SUBJECT: OLD CASTLE ROAD PIPELINE PH. 2 PROJECT
[PROJECT NO. 01-06-78-51420]
ADDENDUM NO. 1

ADDENDUM NO. 1
TO CONTRACT DOCUMENTS AND SPECIFICATIONS
FOR CONSTRUCTION OF THE
OLD CASTLE ROAD PIPELINE PH. 2 PROJECT
[PROJECT NO. 01-06-78-51420]

VALLEY CENTER MUNICIPAL WATER DISTRICT
VALLEY CENTER, CALIFORNIA

OLD CASTLE ROAD PIPELINE- PH 2
PLAN AND PROFILE
19+00.00 TO 28+50.00

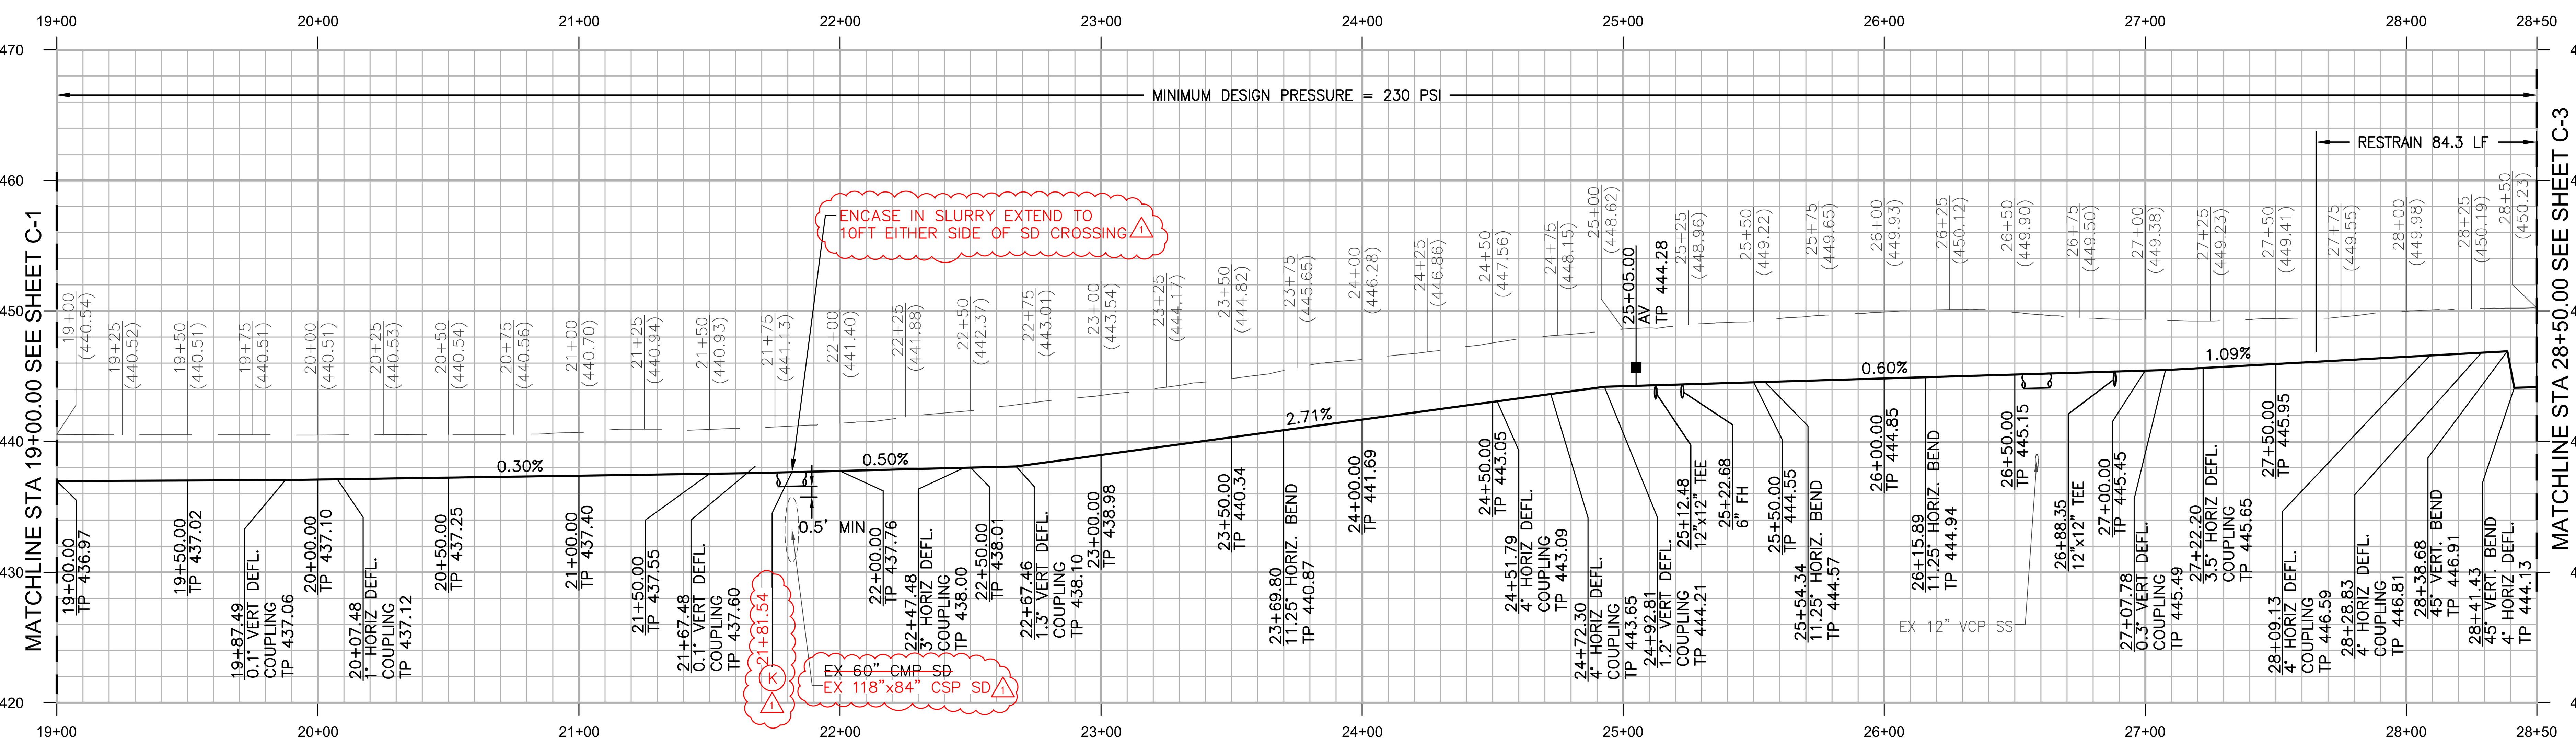
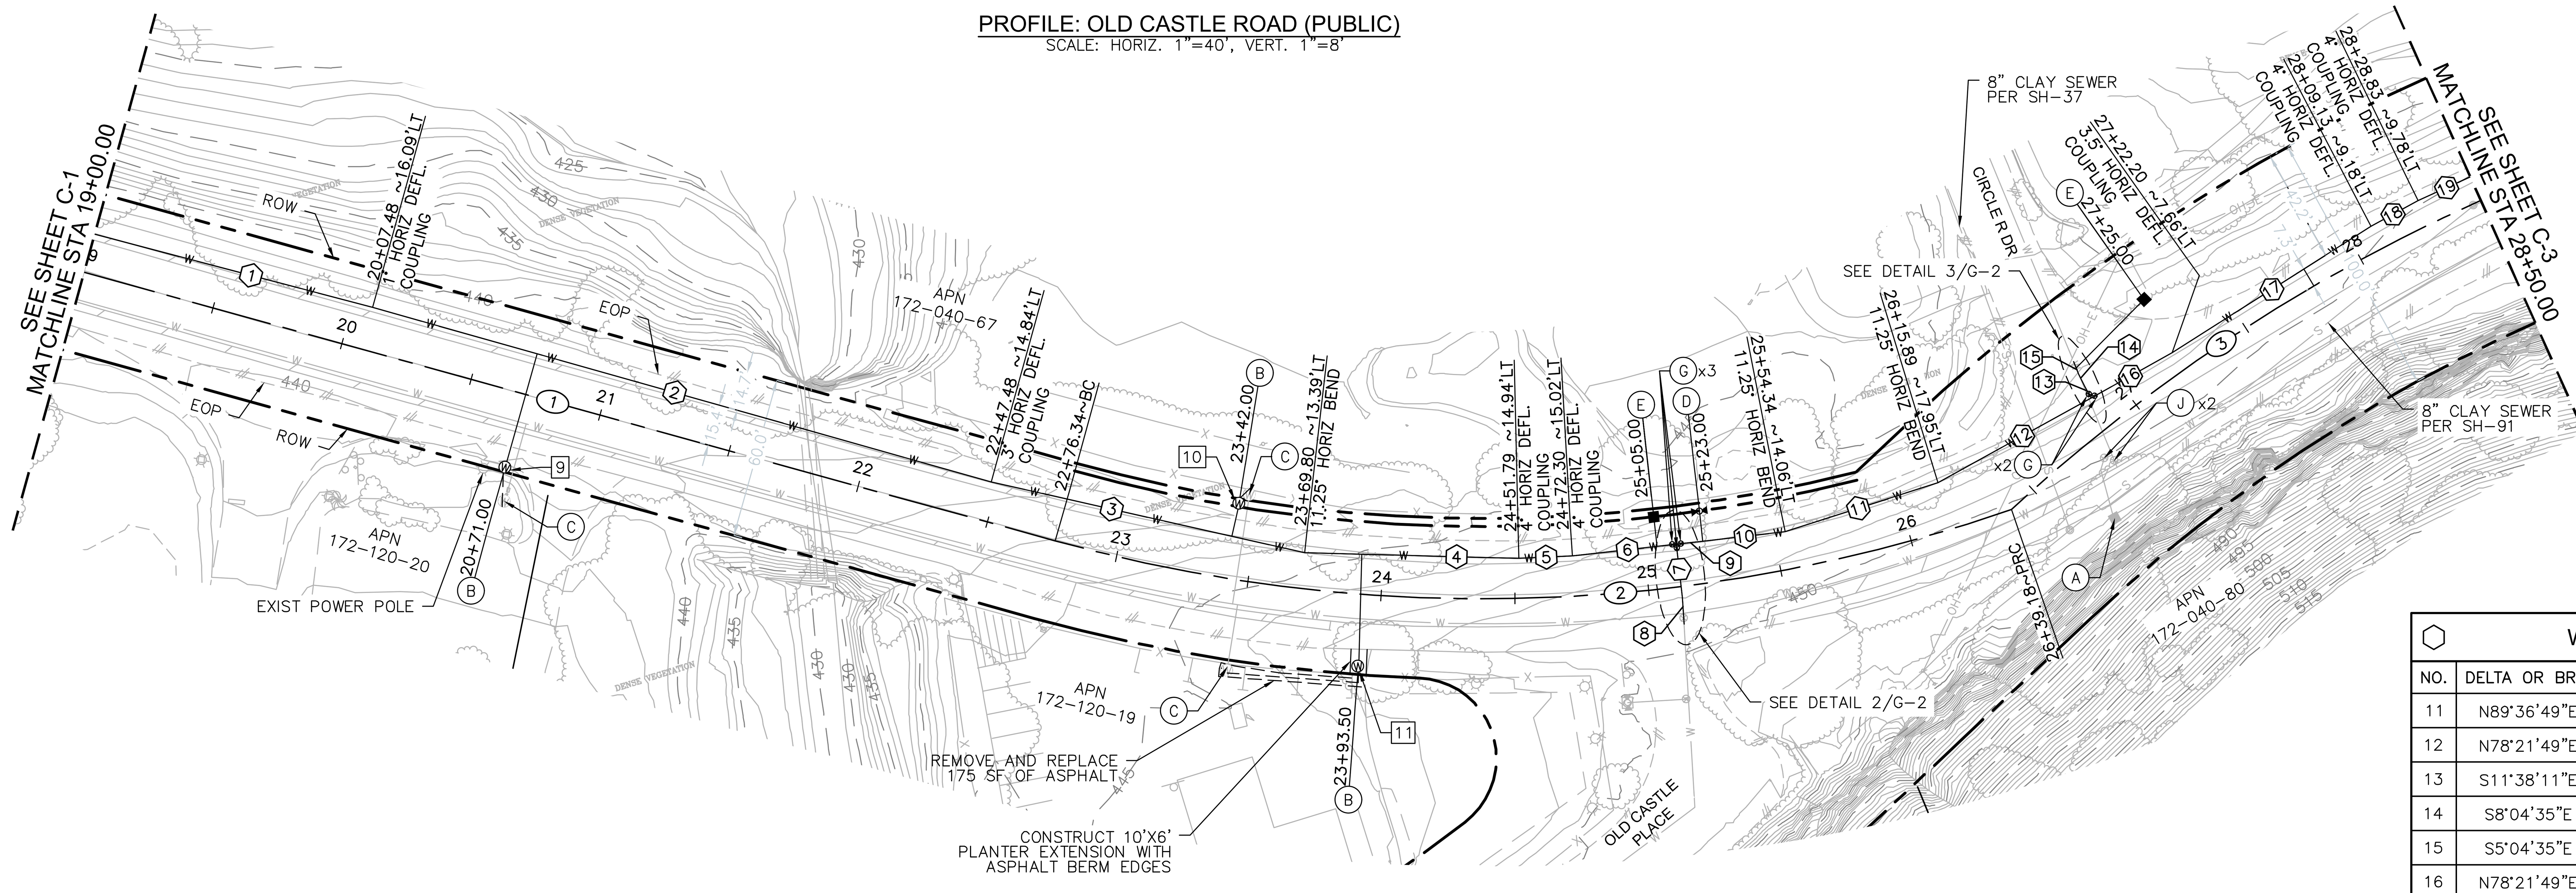
Item No. 5 - Sheet 5 of 34 (C-2)

- STA 22+00: Adds storm drain slurry encasement requirement and updates existing storm drain diameter.
- Requires a full 20-foot stick of C900 centered at the storm drain crossing.

OLD CASTLE ROAD PIPELINE- PH 2
PLAN AND PROFILE
28+50.00 TO 39+50.00

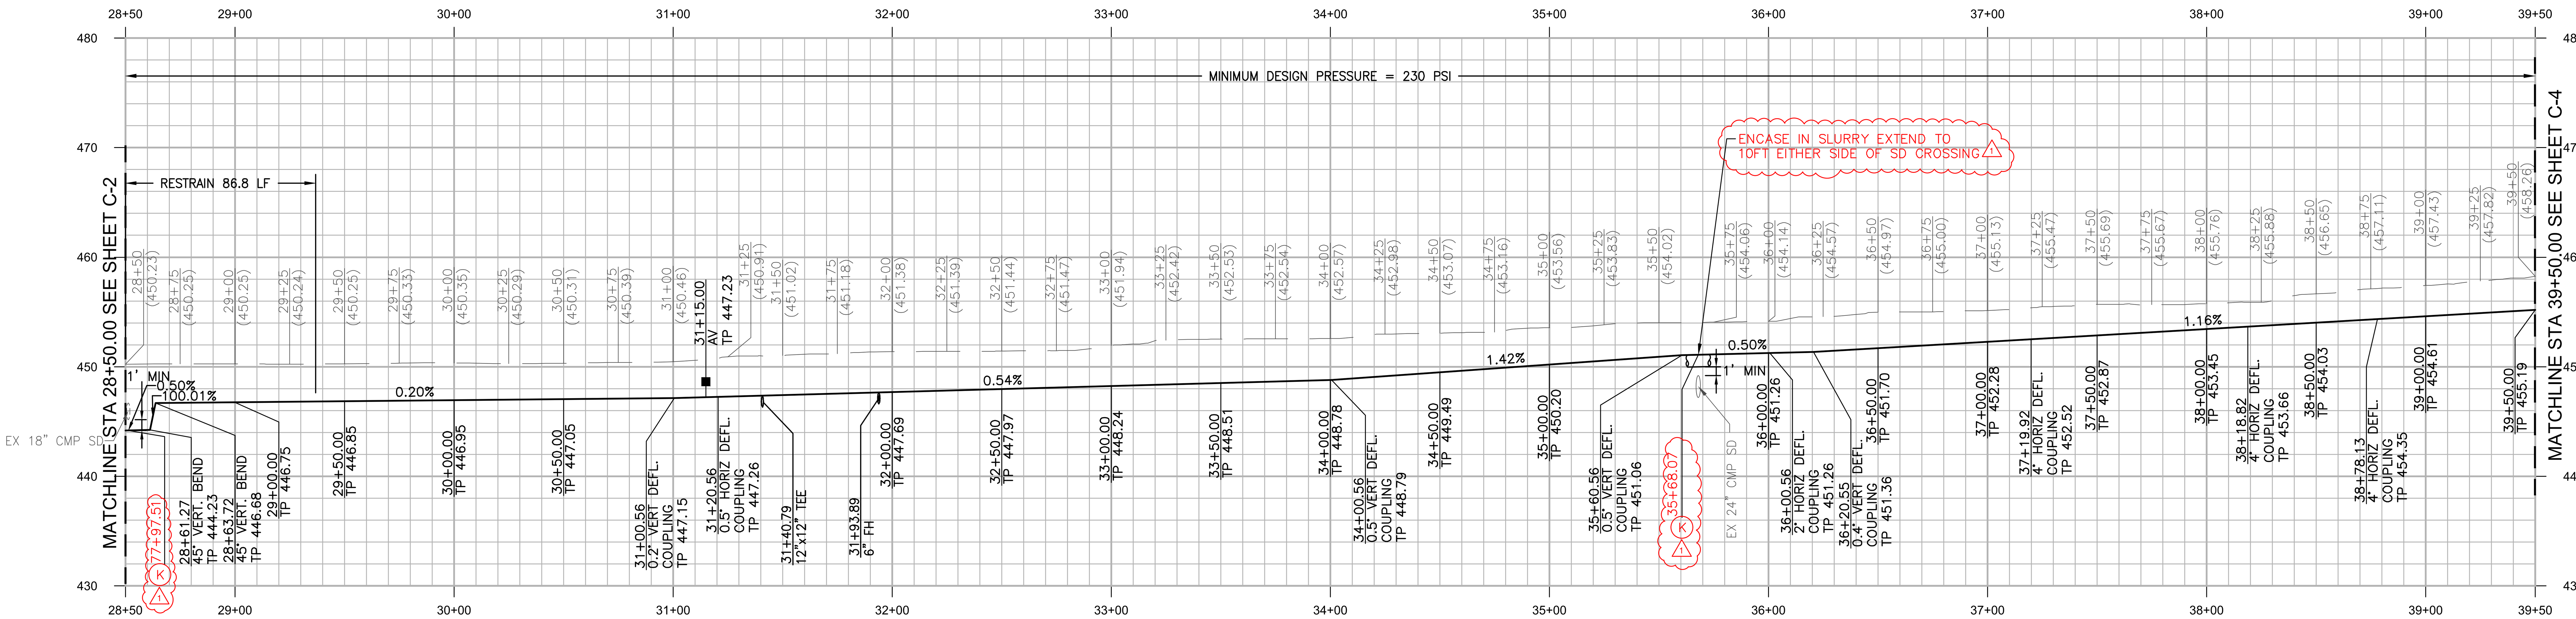
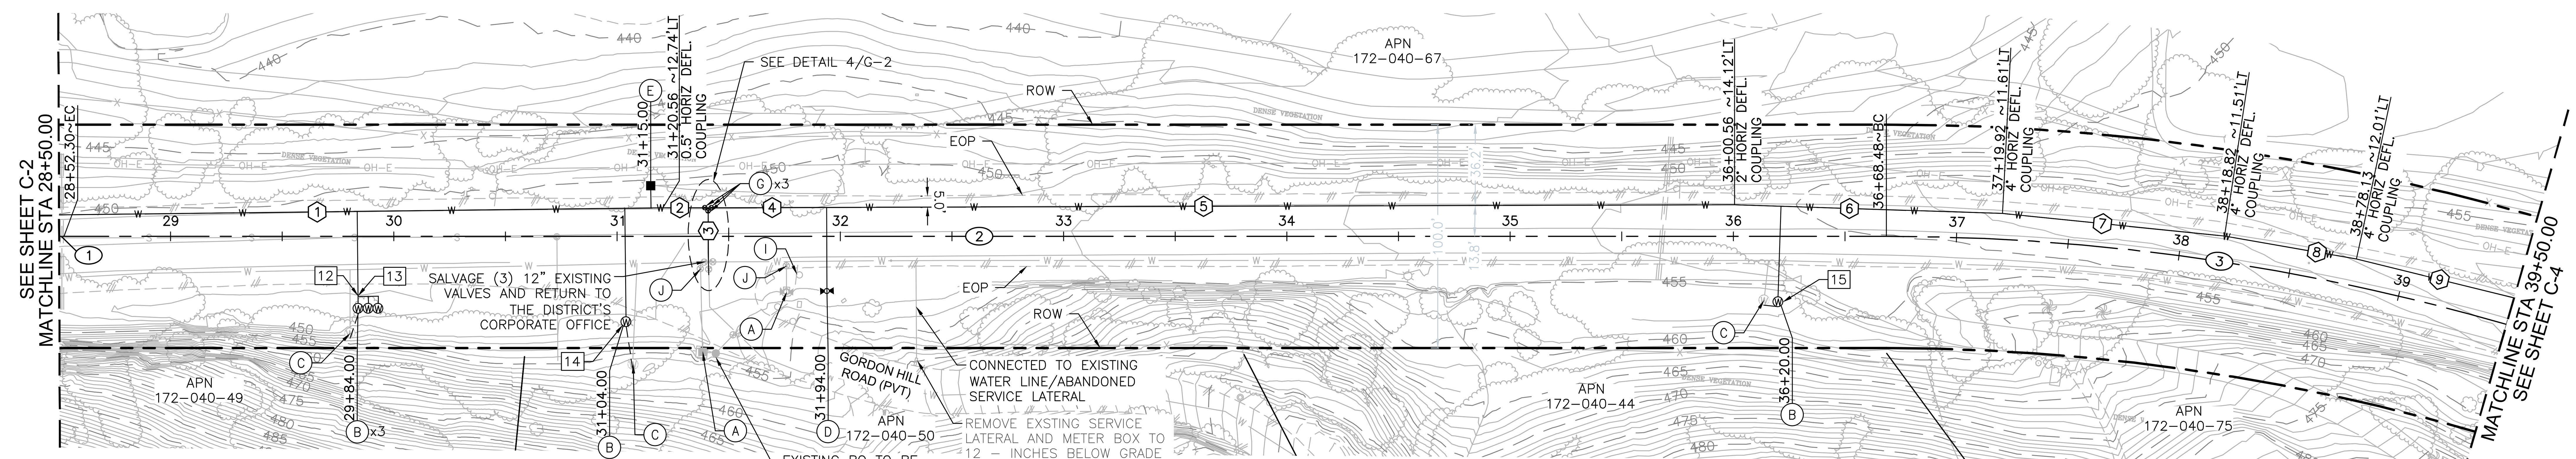
Item No. 6 - Sheet 6 of 34 (C-3)

- Adds storm drain slurry encasement requirement and updates existing storm drain diameter.

- Requires a full 20-foot stick of C900 centered at storm drain crossing.

OLD CASTLE ROAD PIPELINE- PH 2
PLAN AND PROFILE
60+00.00 TO 70+00.00

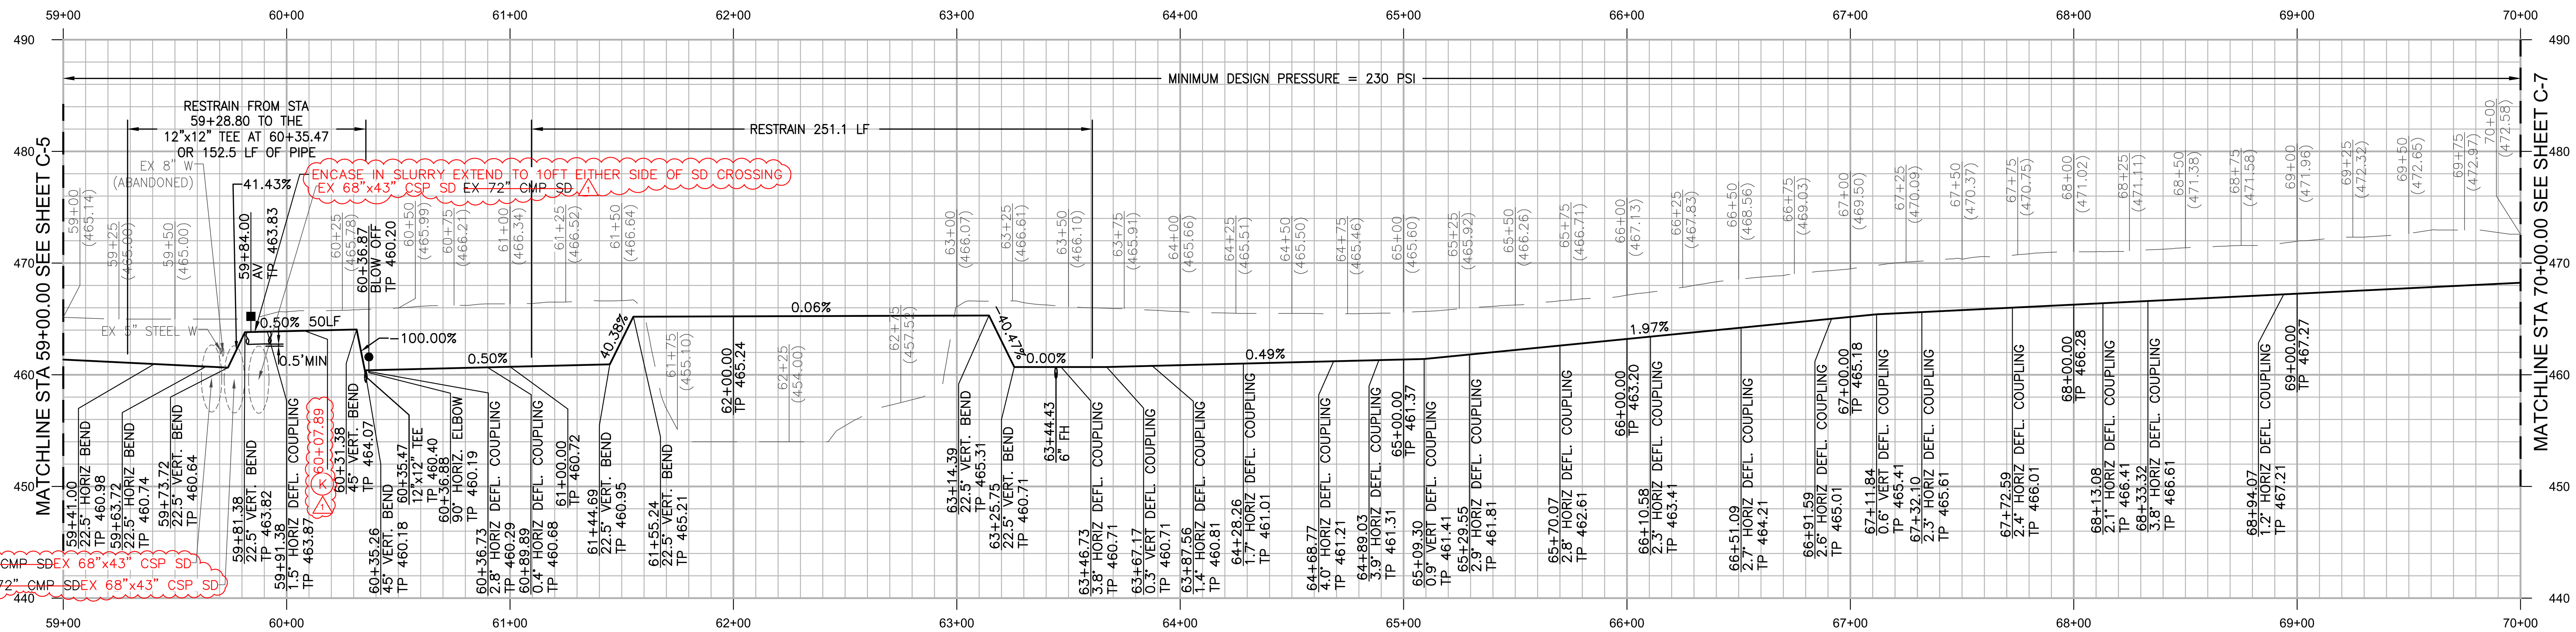
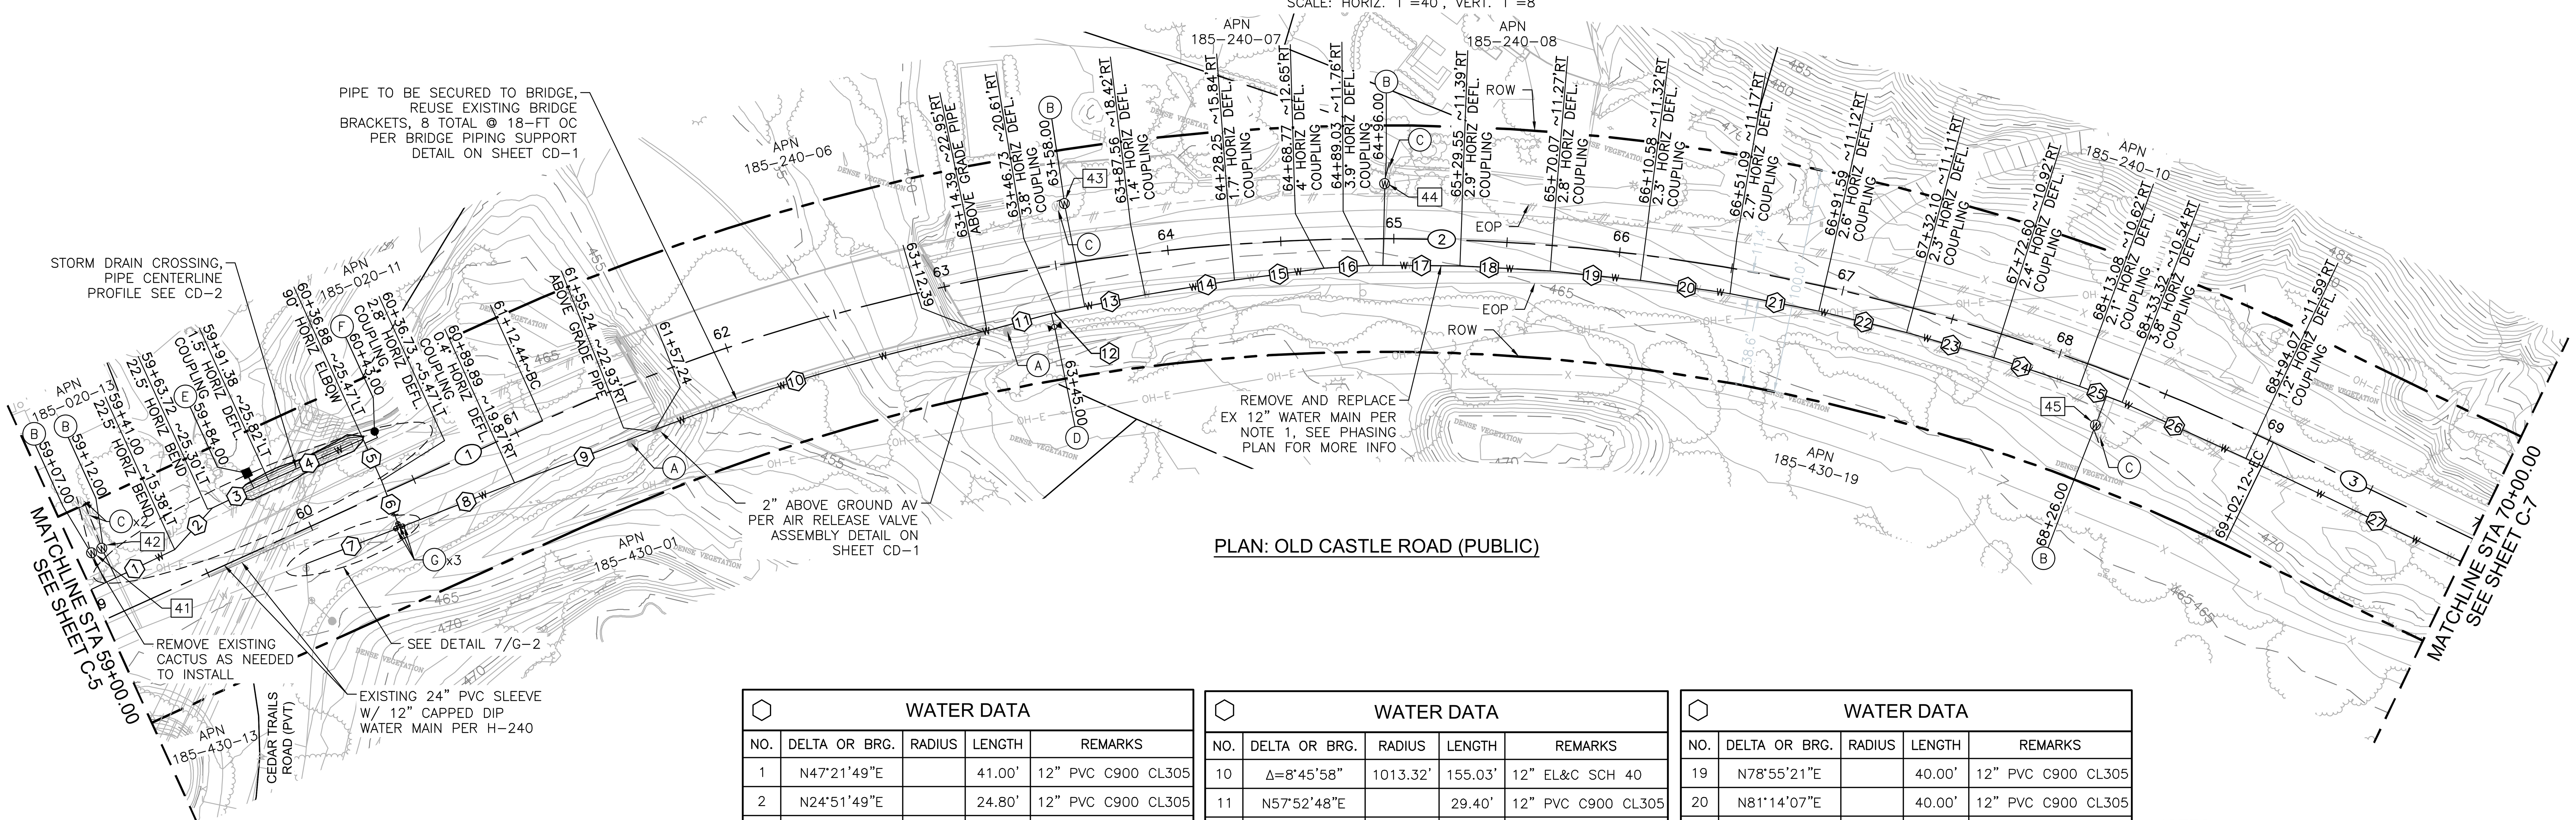
Item No. 7 - Sheet 9 of 34 (C-6)

- STA 59+80: Adds storm drain slurry encasement requirement and updates existing storm drain diameter.
- Requires a full 20-foot stick of C900 centered at the storm drain crossing.
